STAFF REPORT
WEST ALLIS PLAN COMMISSION
Wednesday, September 24, 2025
6:00 PM

3. Site, Landscaping, and Architectural Design Amendment for SoNa Lofts Phase II, Lot 4, a proposed 5+ Unit Dwelling, at 6600 W. Mitchell St. (Tax Key No. 454-0656-000).

SoNa Phase II
Site, Landscaping and Architectural Amendment
August 2025

Previous Elevations:

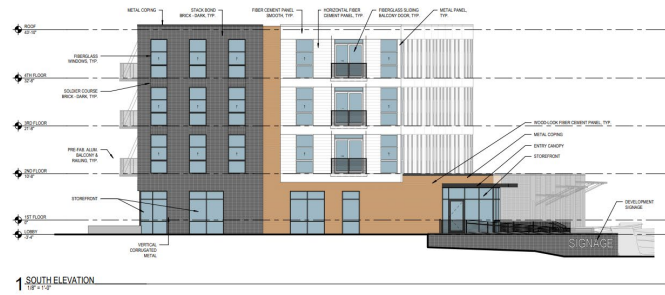
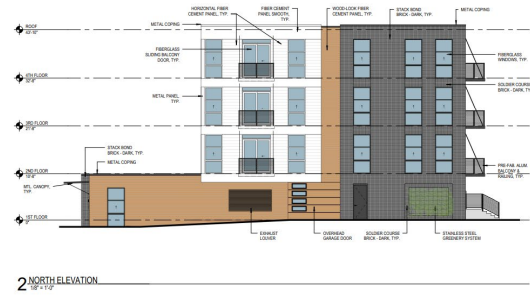
The major changes to the overall building focus intensely on the architecture. The proposed 51-unit apartment building will still compromise of one primary building. In previous designs the building was shown to have two masses visually pulled in opposite directions. A design element similar to this is still on display with the west half of the building covered in a dark brick, while the east half is composed of white fiber cement panel. Additionally, the ground-level town home units that were previously made up of 6 red, geometric forms have been replaced visually with an alternating pattern of dark colored brick and wood-look cement panel.

Previous exterior materials consisted largely of Nichiha paneling and Hardie lap siding.
